607673-109183

**ADDENDUM NO. 2**

**WARREN**  
**Bridge Replacement Br. No. W-07-002 (Steel) Route 67 (Main Street) over  
the Quaboag River**

Responses to Bidder's Questions

**TYPICAL UTILITY DETAILS AT ABUTMENT**

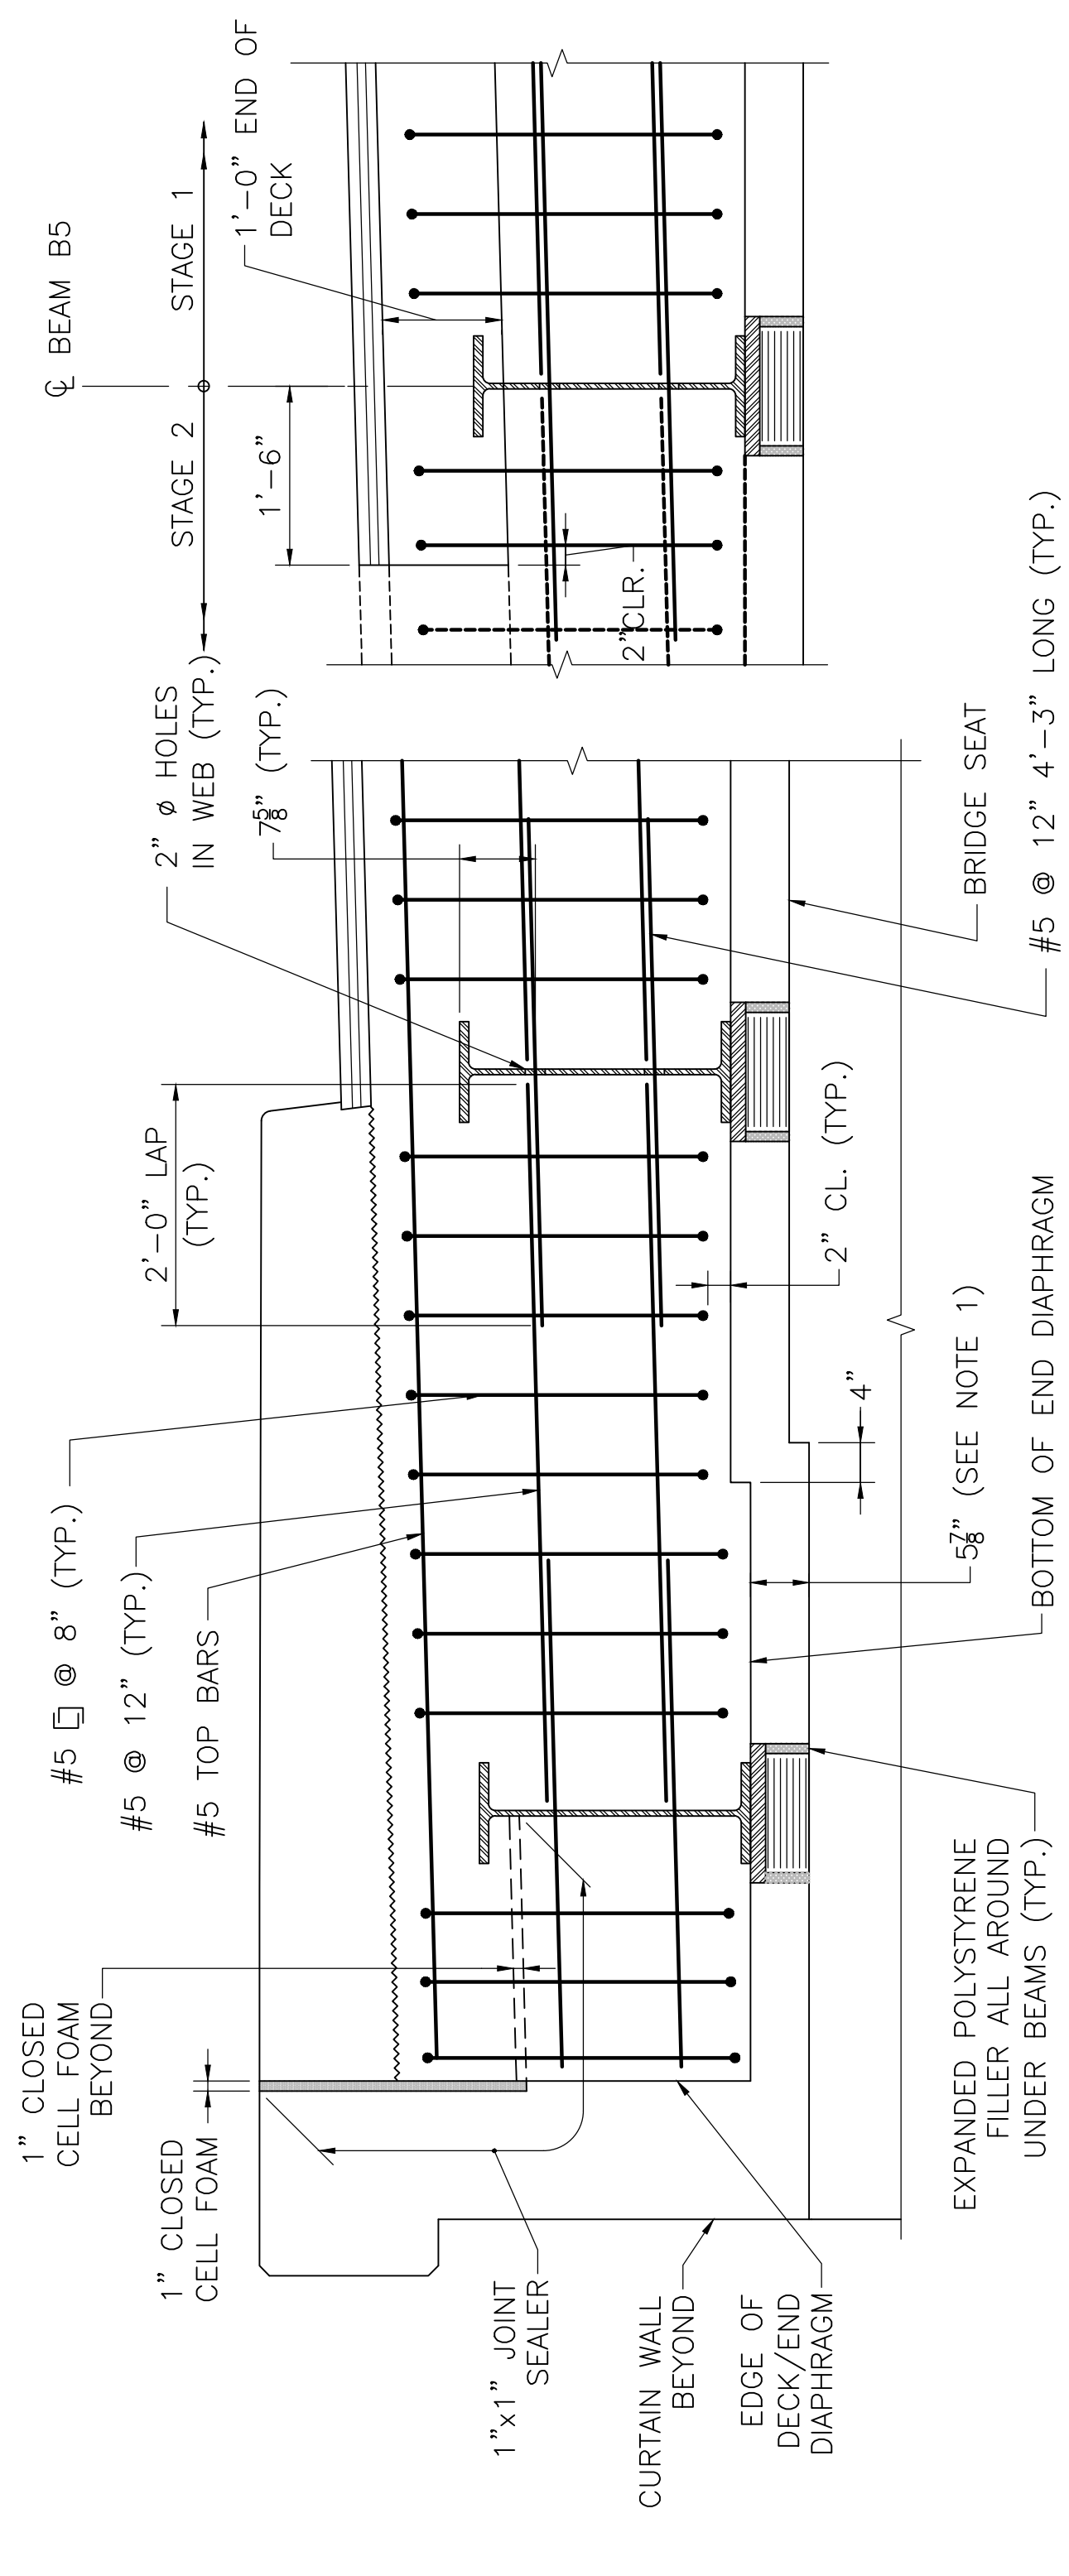
Question 2) Sheet 31 of 52, Water Line, Typical Utility Details at Abutment, appears to show a pipe sleeve through the abutment, bending down and continuing to the end of the approach slab. It is not possible to install ductile iron water pipe inside a bent sleeve. Please clarify if the limits of the steel sleeve extend beyond the bends of the water pipe.

Response 2) Refer to the revised Plans, Sheet No. 31 of 52. The steel sleeve for the waterline can end prior to the bend so that it only extends through the abutment backwall and the end diaphragm.
